**ADDENDUM NO. 1
FEBRUARY 26TH, 2026**

PROJECT: ANSON ISD
ELEMENTARY & HIGH SCHOOL CLASSROOM ADDITION

BID DATE: MARCH 5TH, 2026

ANSON ISD
HIGH SCHOOL CLASSROOM ADDITION
FRAMING DETAILS

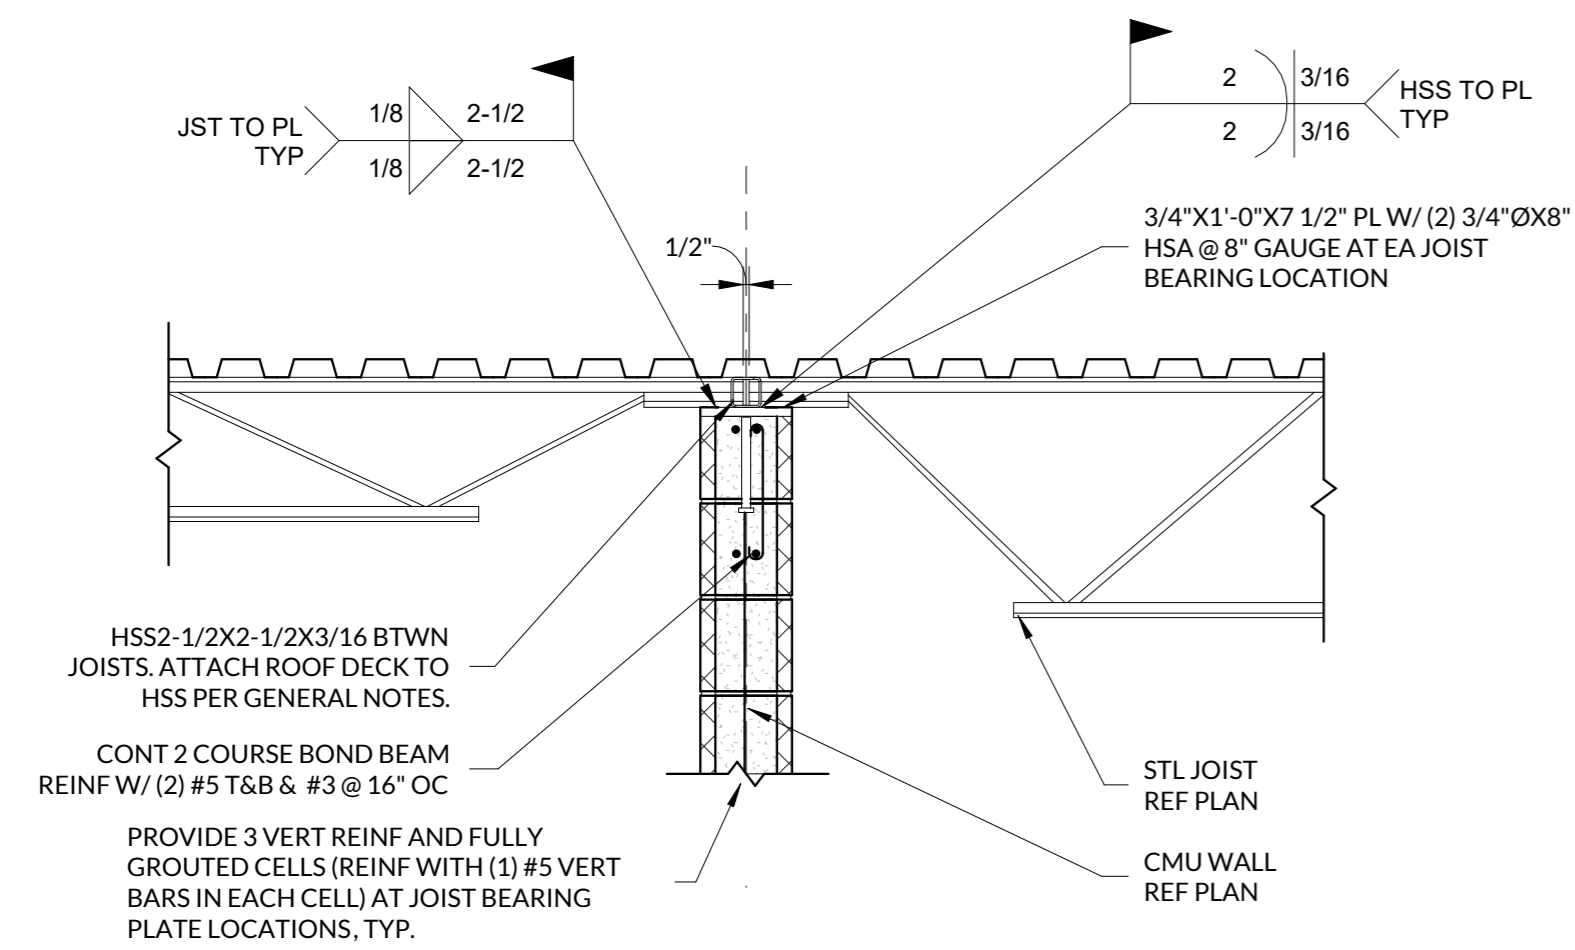
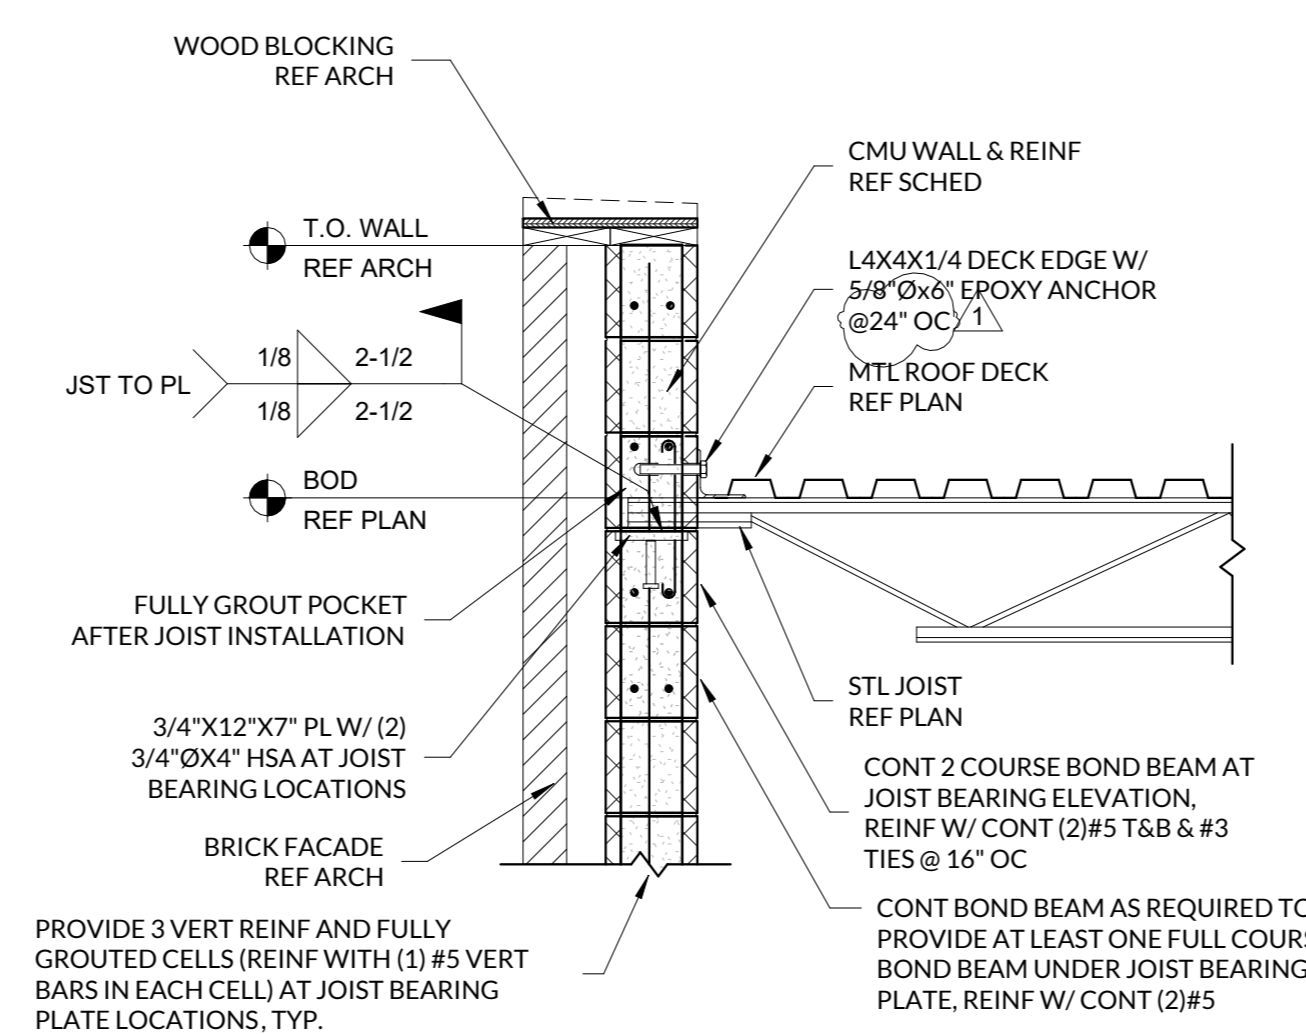
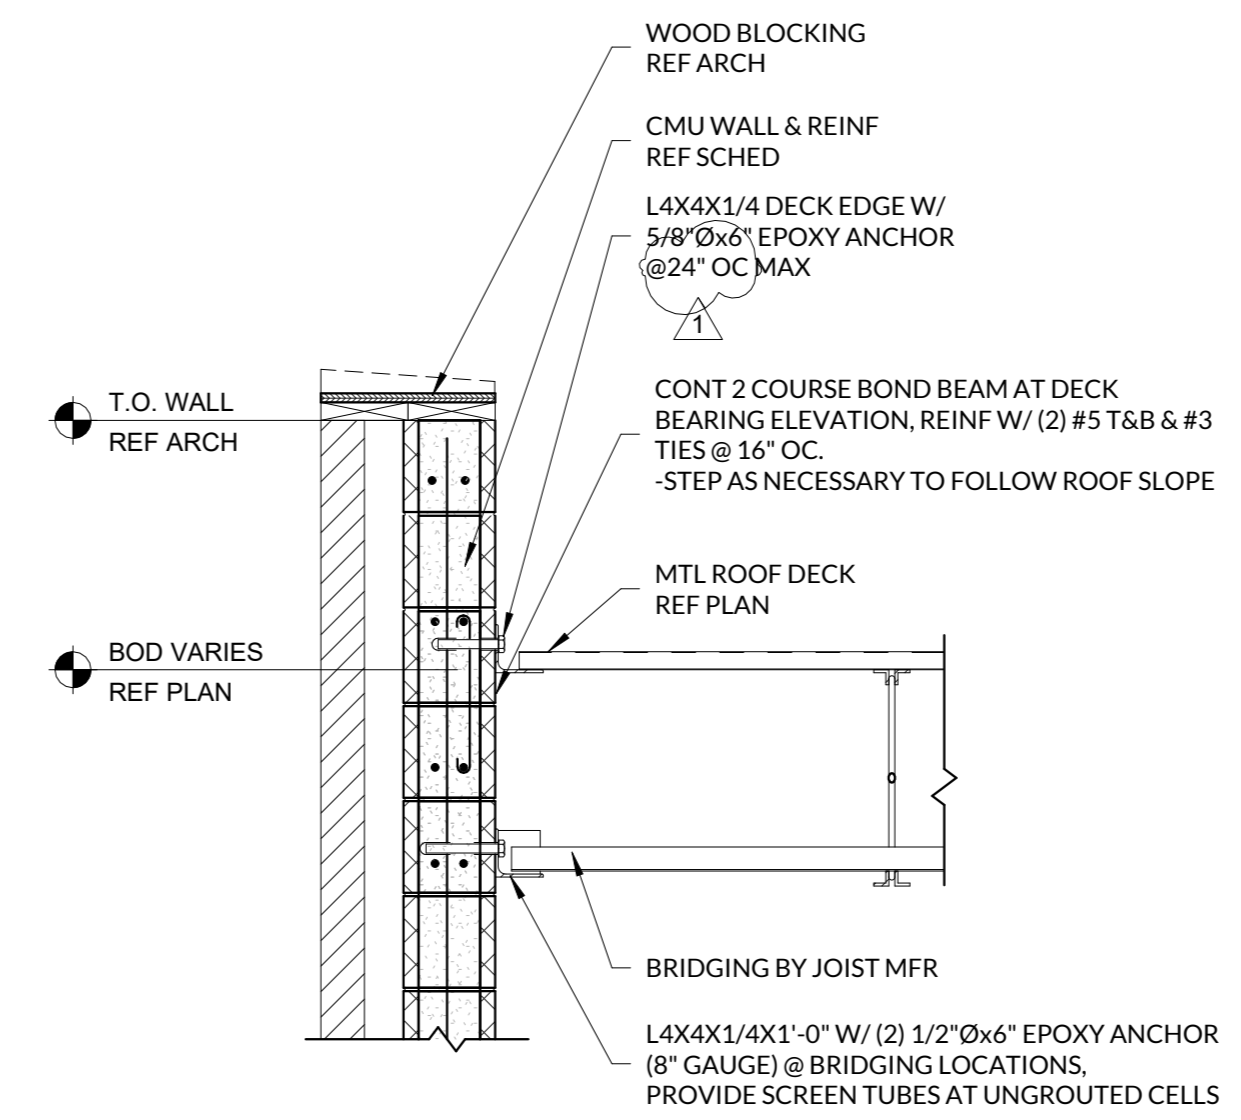
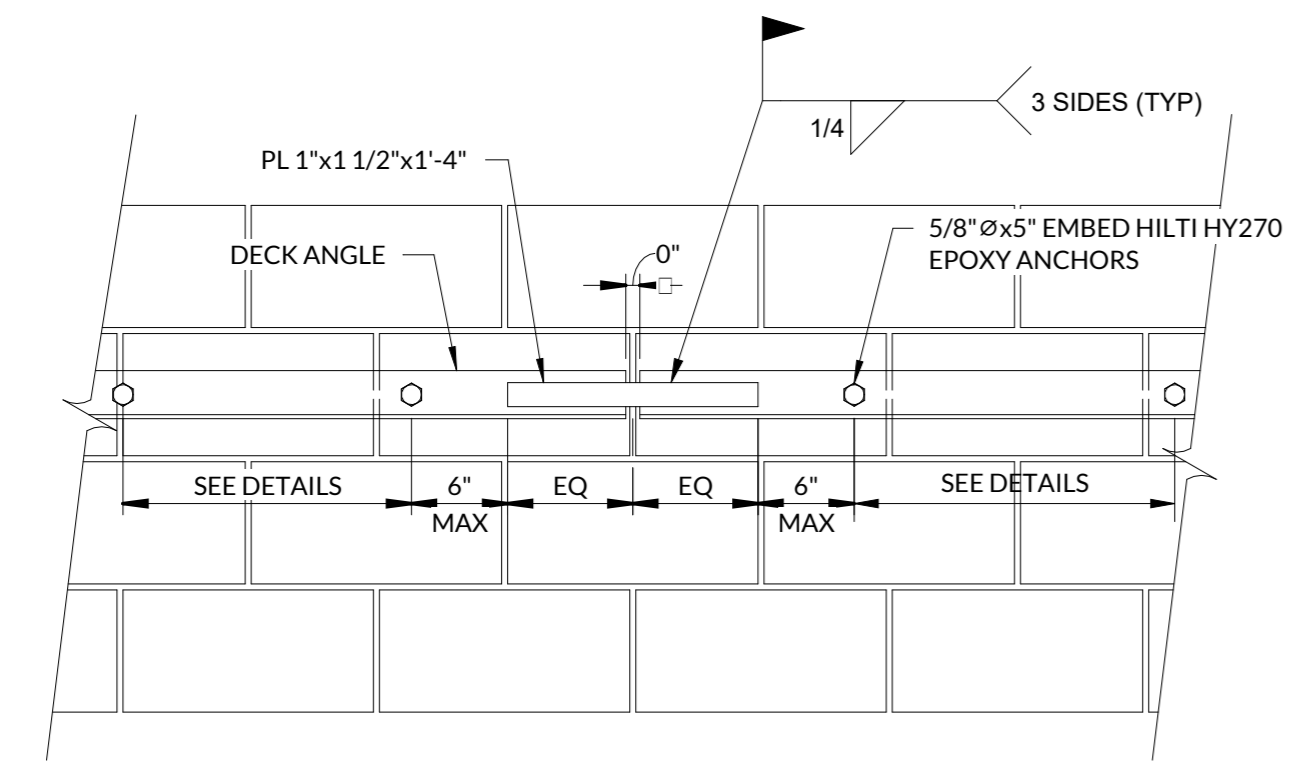
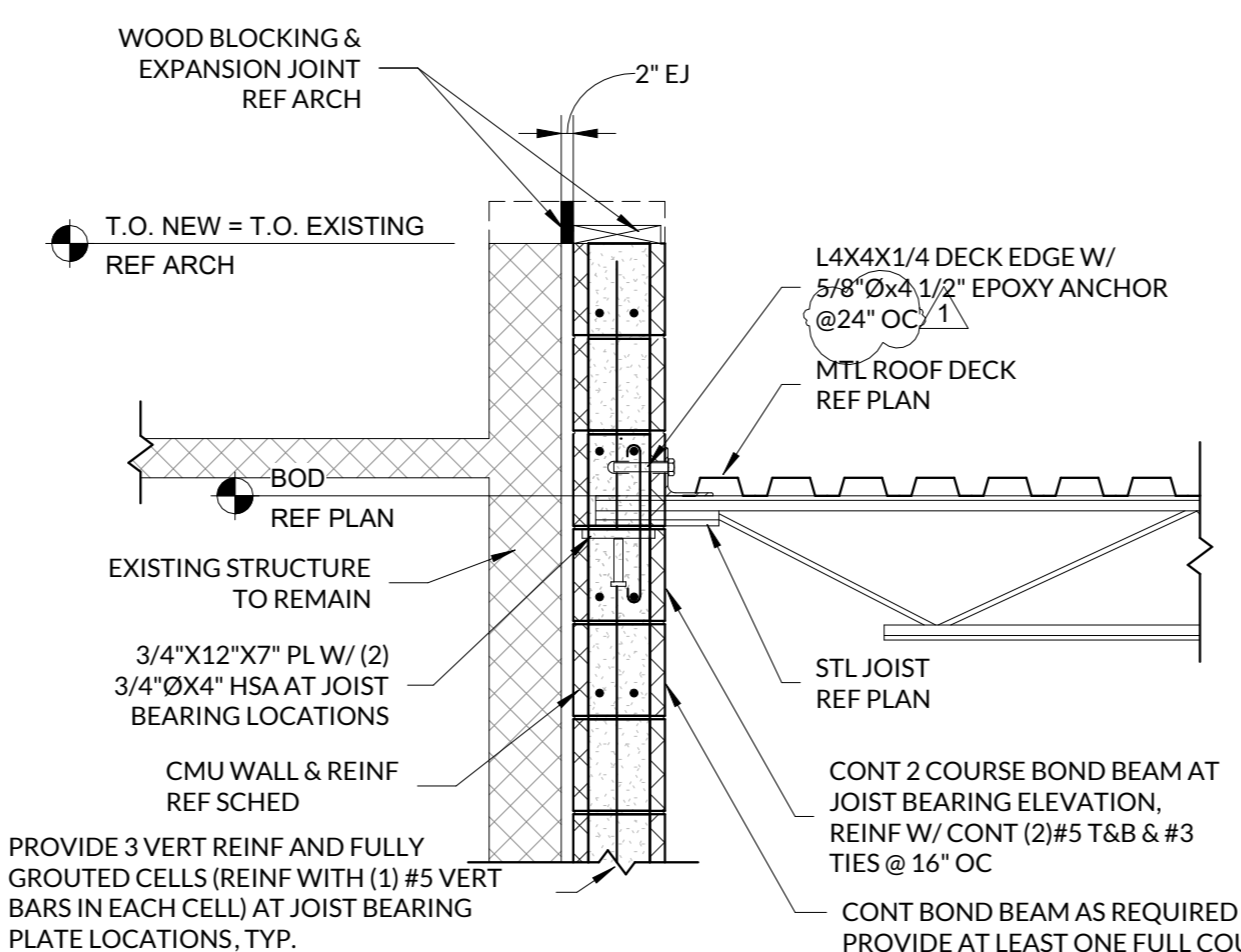
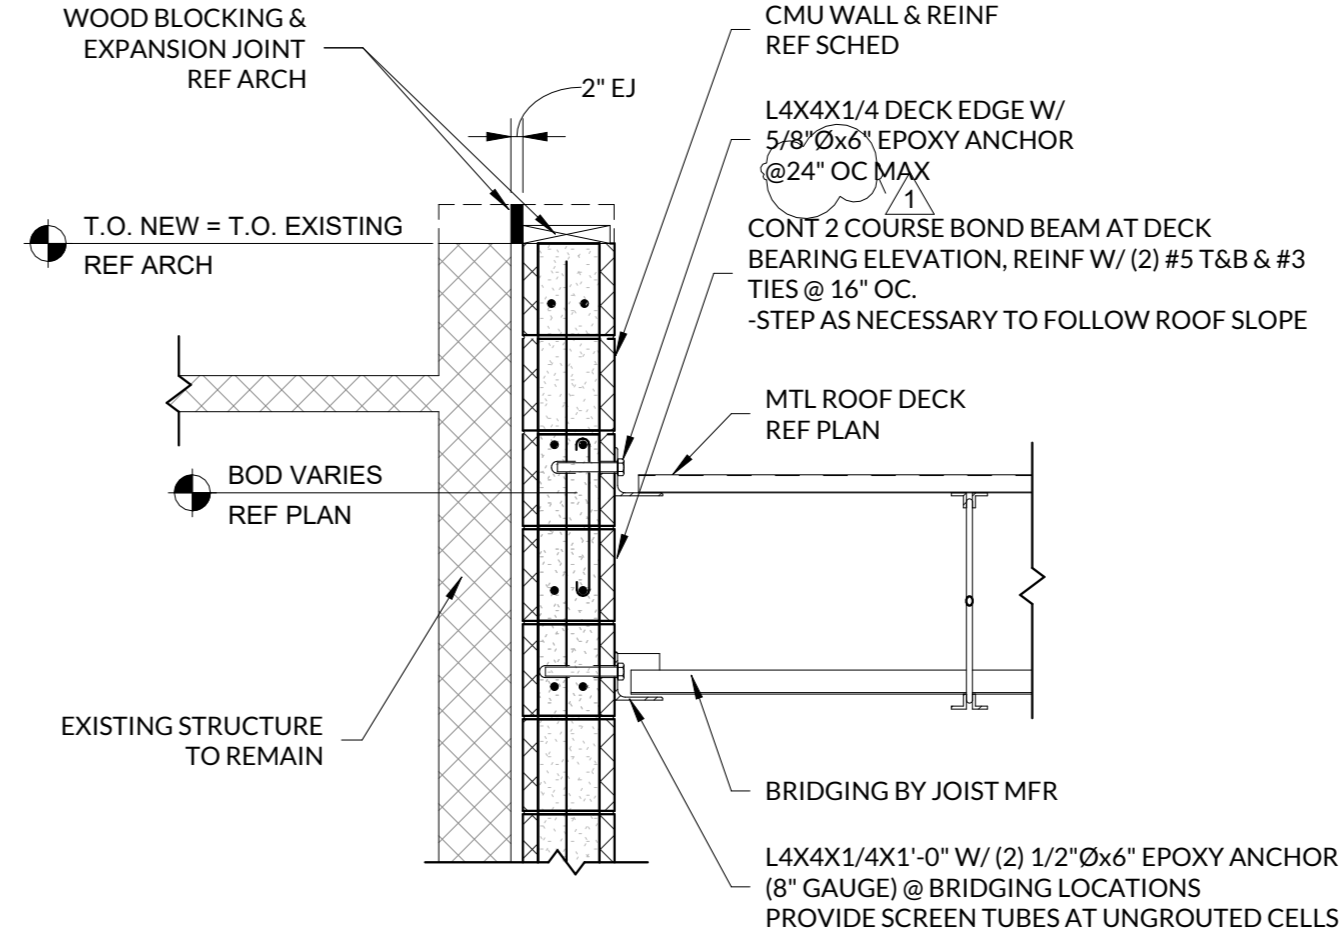
- Item #D12** **Sheet 2S4.0** – REPLACE sheet with attached sheet 2S4.0 dated 02-26-206. REVISED framing details.
- Item #D13** **Sheet 2M2.1** – REPLACE sheet with attached sheet 2M2.1. dated 02-26-2026. UPDATED mechanical plan making changes in Storage 101.

DATE	02/26/2026
NO.	REVISION
ADDENDUM #1	
PROJECT #	25320
SCALE	1/8" = 1'-0"
BAR IS ONE INCH IN LENGTH ON ORIGINAL DRAWING. CHECK SCALE AND ADJUST ACCORDINGLY.	
SEQ.	SHEET
	2E2.1

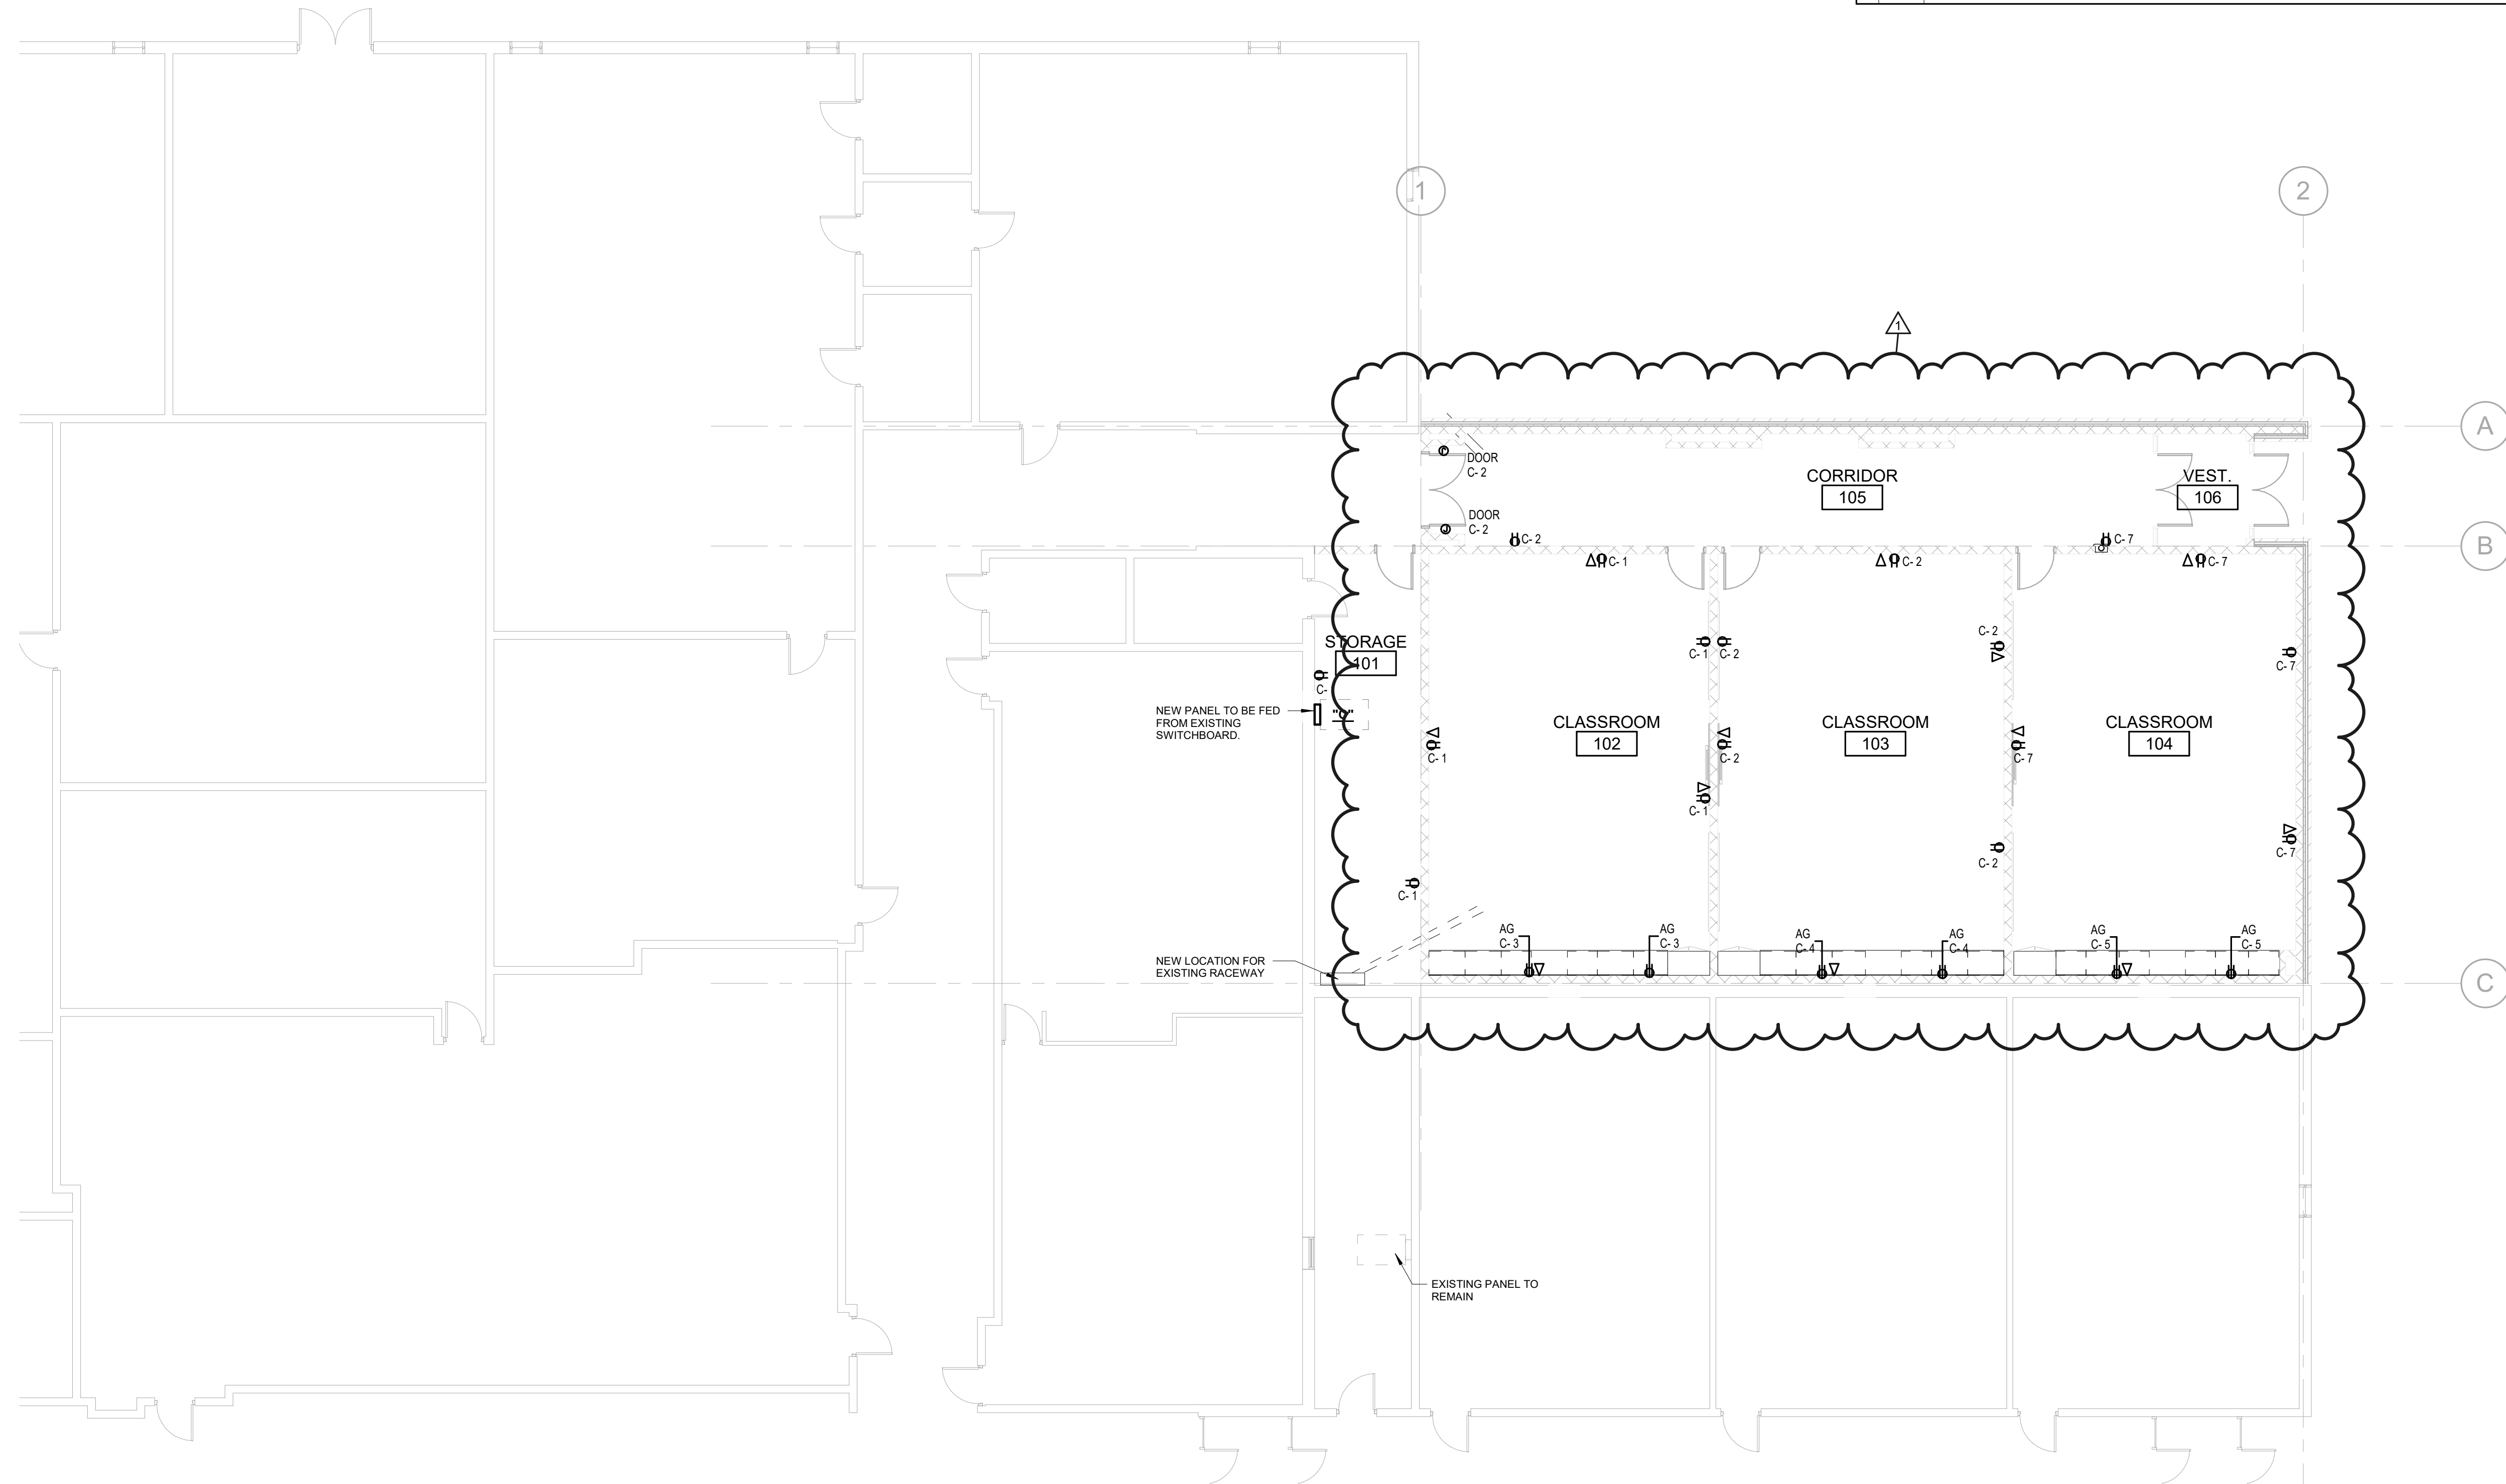
- Item #D15** **Sheet 2E2.1** – REPLACE sheet with attached sheet 2E2.1 dated 02-26-2026. UPDATED power plan with updated raceway location & cleaned up floor plan background.
